TITLE
 CLUB CAR CONVERSION (GEN1 TO GEN2)

SIZE **A** FSCM NO. DWG NO. 62-CCLB-A0-100 REV
 SCALE www.fsip.biz SHEET

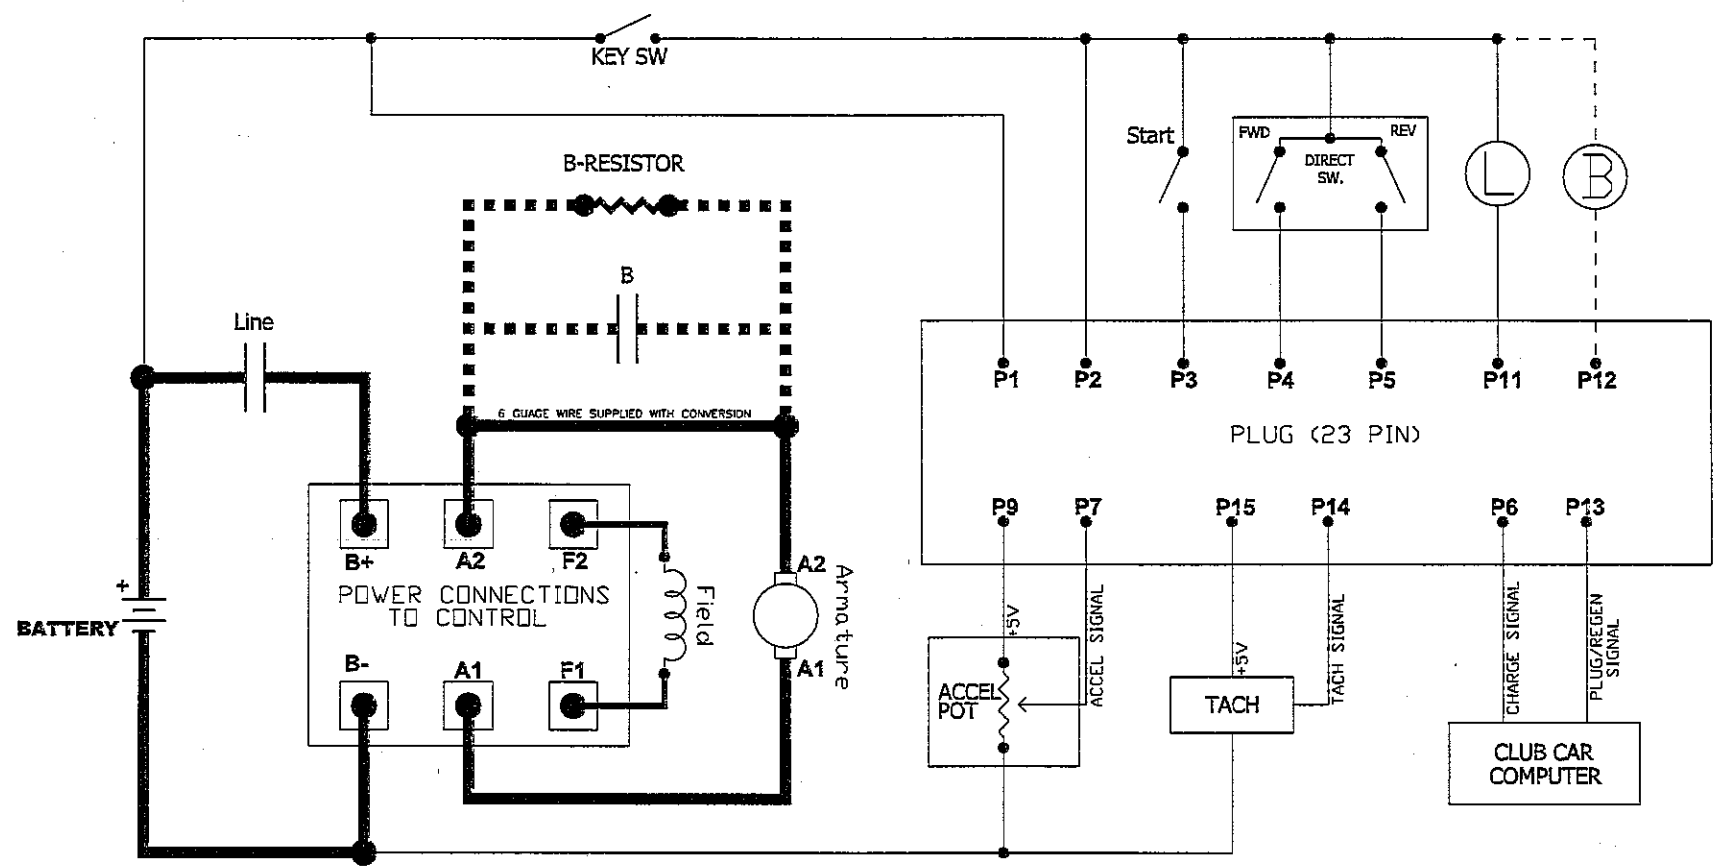
NOTE: B-RESISTOR AND CONTACTOR ARE OPTIONAL ON SOME MODELS AND ARE NOT NEEDED WITH UPGRADE
 A 6 GAUGE WIRE (SUPPLIED WITH CONVERSION) SHOULD BE INSERTED BETWEEN A2 OF CONTROL AND A2 OF MOTOR TO BYPASS
